ADDENDUM

JANUARY 31, 2018

RFB NO. 317040 - ADDENDUM NO. 1

PHASE 9, CELL 2 LINER AND STAGE 4 FINAL CAP CONSTRUCTION

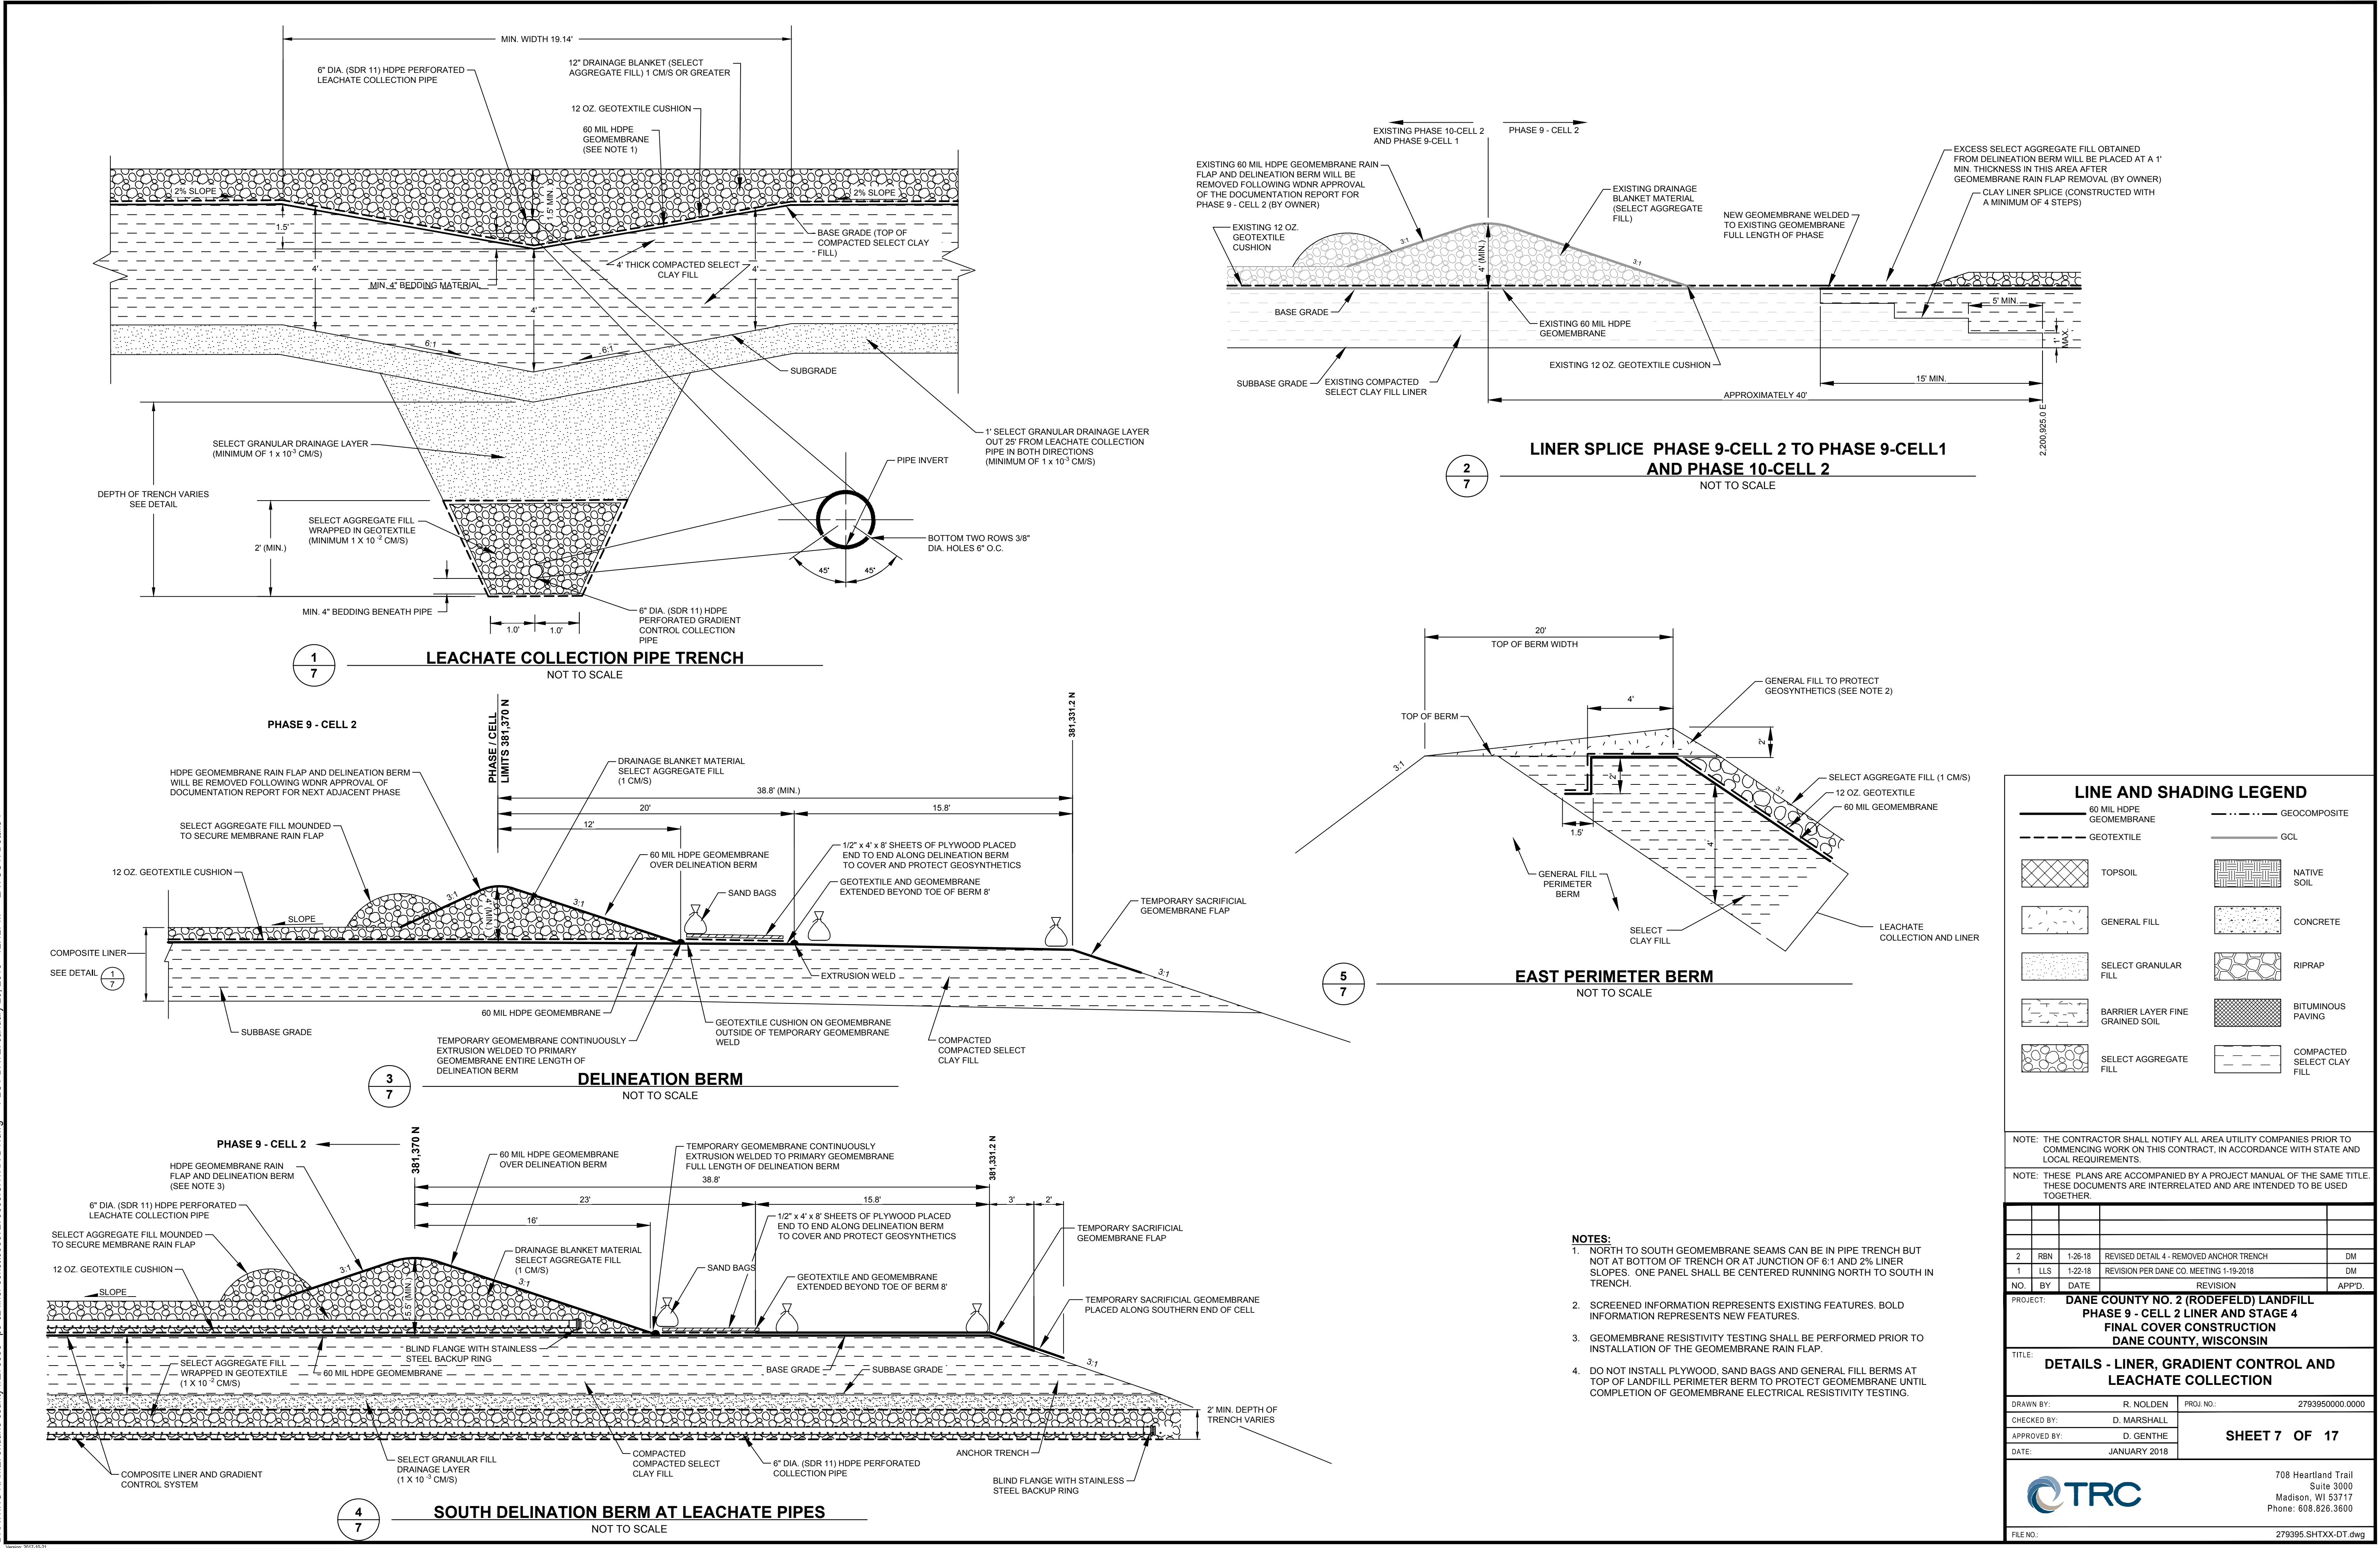
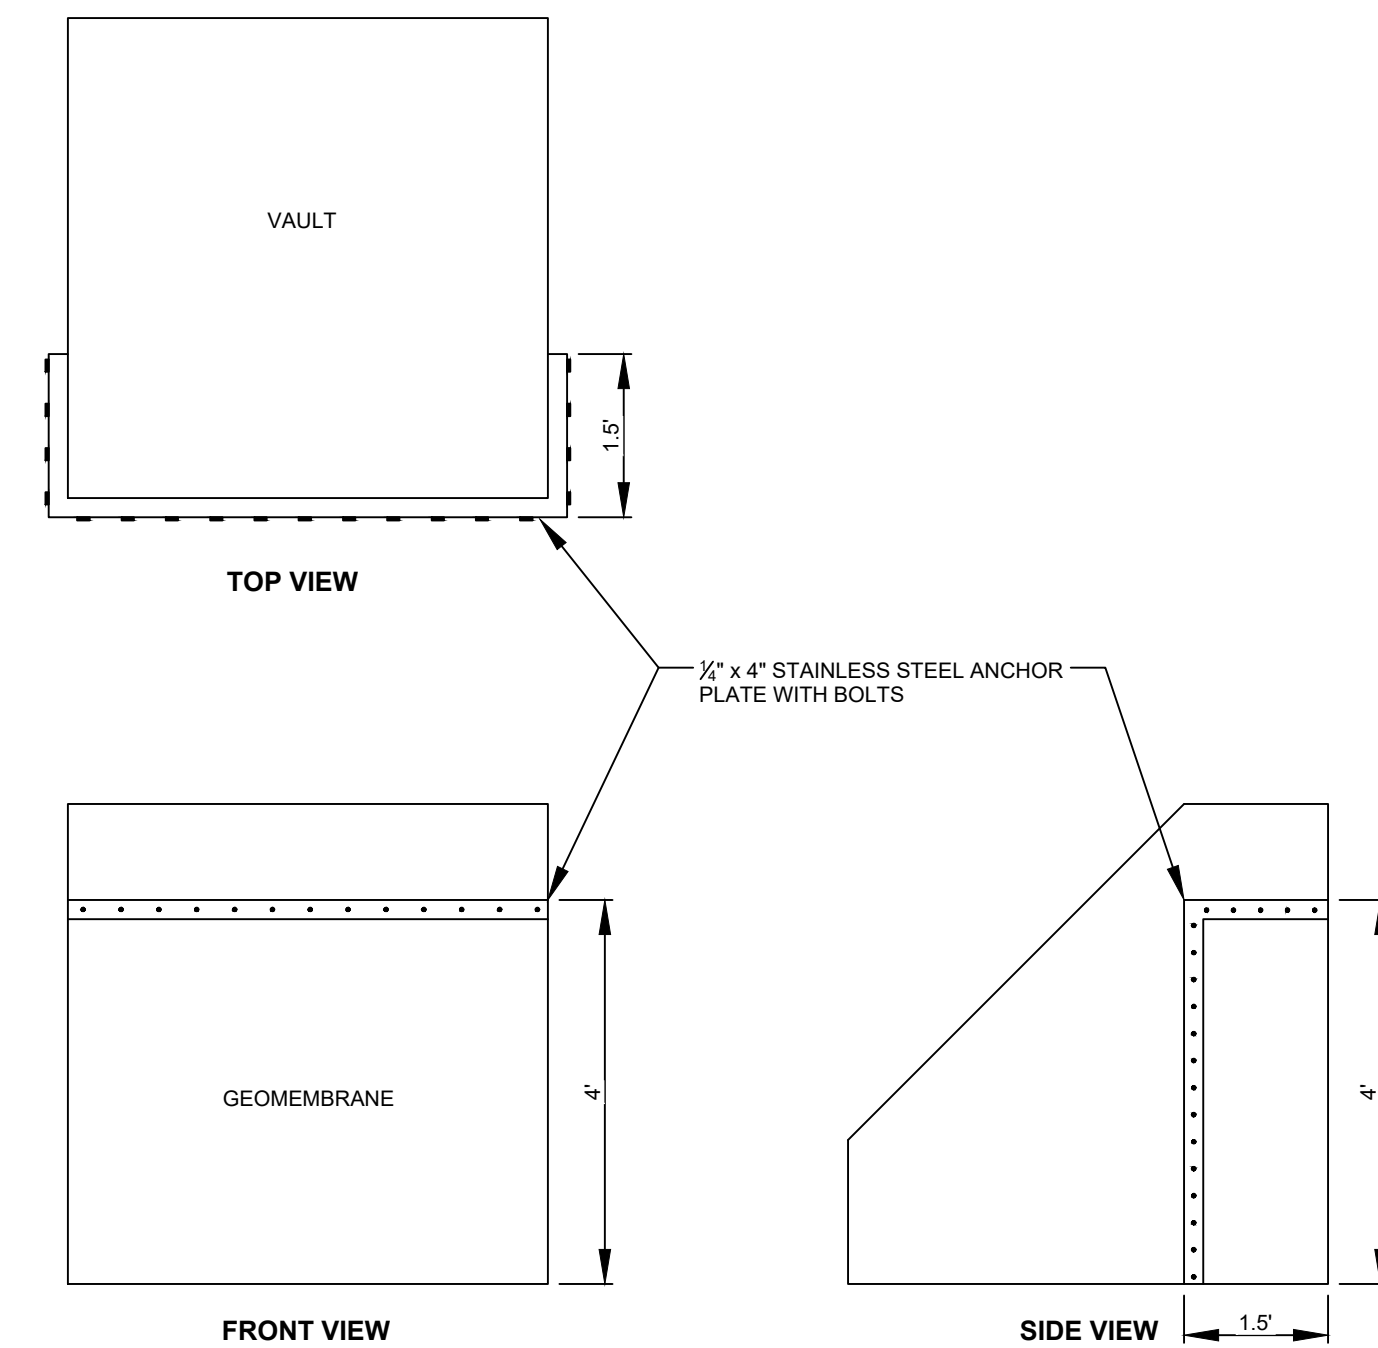
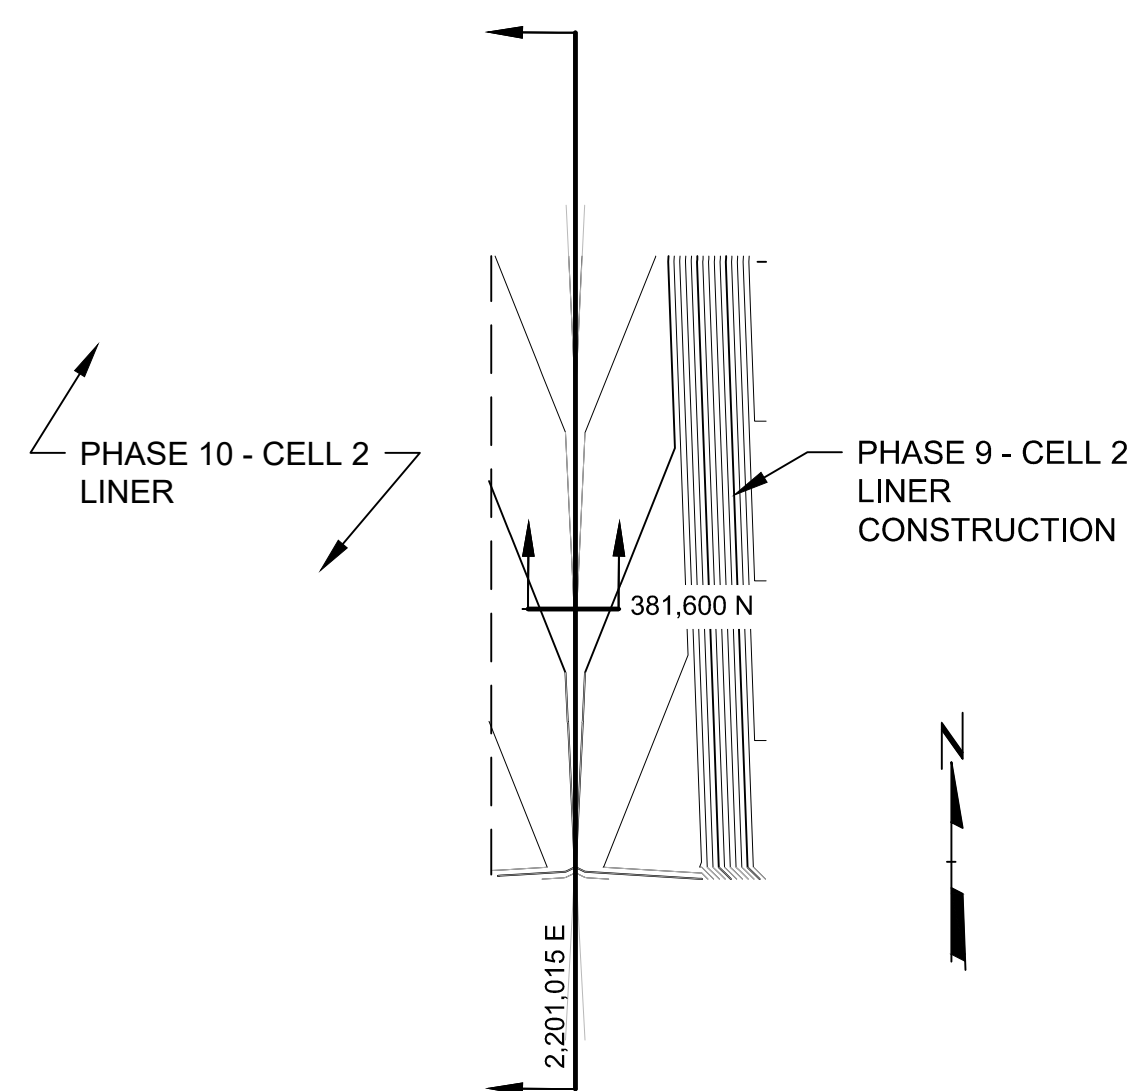
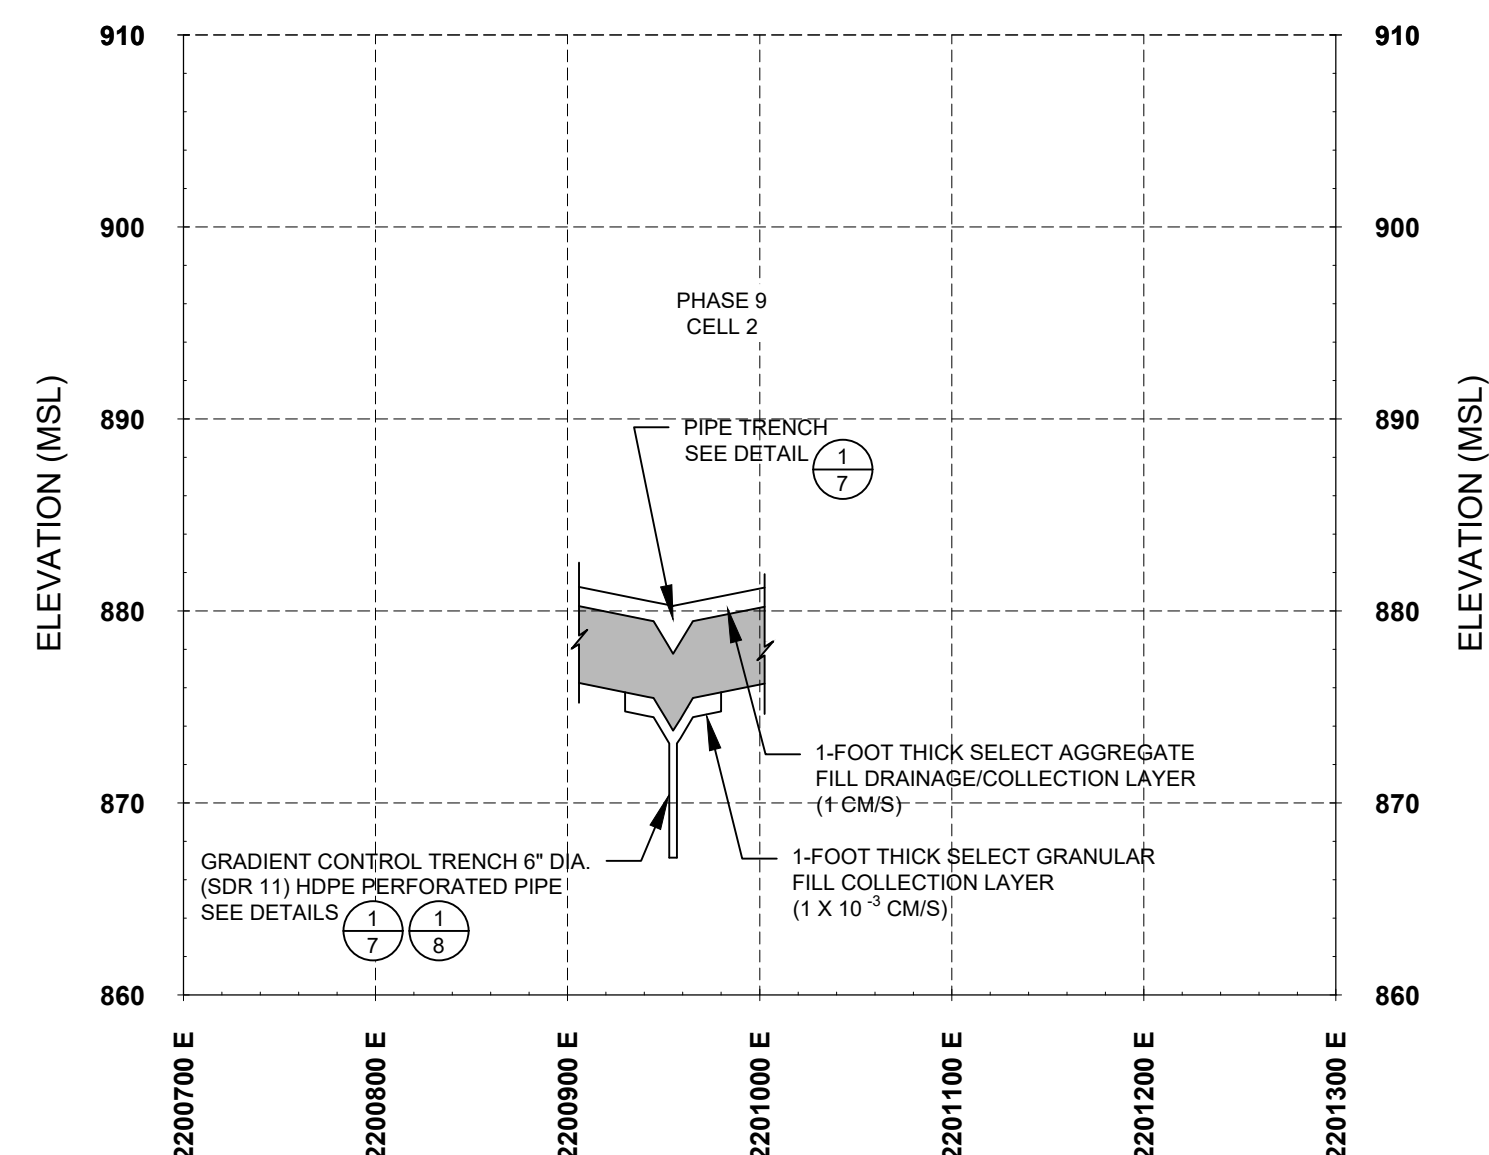
- a. Sheet 7, Detail 4: Removed anchor trench;
- b. Sheet 9: Added callout "Limits of Stage 3 Soil Barrier Layer";
- c. Sheet 10: Added a callout "Limits of Stage 3 Geosynthetics", added screened line showing Stage 3 Geosynthetics extent, added Note 5, and edited grading limits to reflect northern capping perimeter line;
- d. Sheet 11: Grading limits edited to reflect northing capping perimeter line;
- e. Sheet 12, Detail 3: Screened existing geosynthetics to location of tie-in, legend changed to read "Geomembrane" instead of "60-mil HDPE Geomembrane";
- f. Sheet 13: Legend changed to read "Geomembrane" instead of "60-mil HDPE Geomembrane";
- g. Sheet 14: Legend changed to read "Geomembrane" instead of "60-mil HDPE Geomembrane"; and
- h. Sheet 15: Legend changed to read "Geomembrane" instead of "60-mil HDPE Geomembrane".
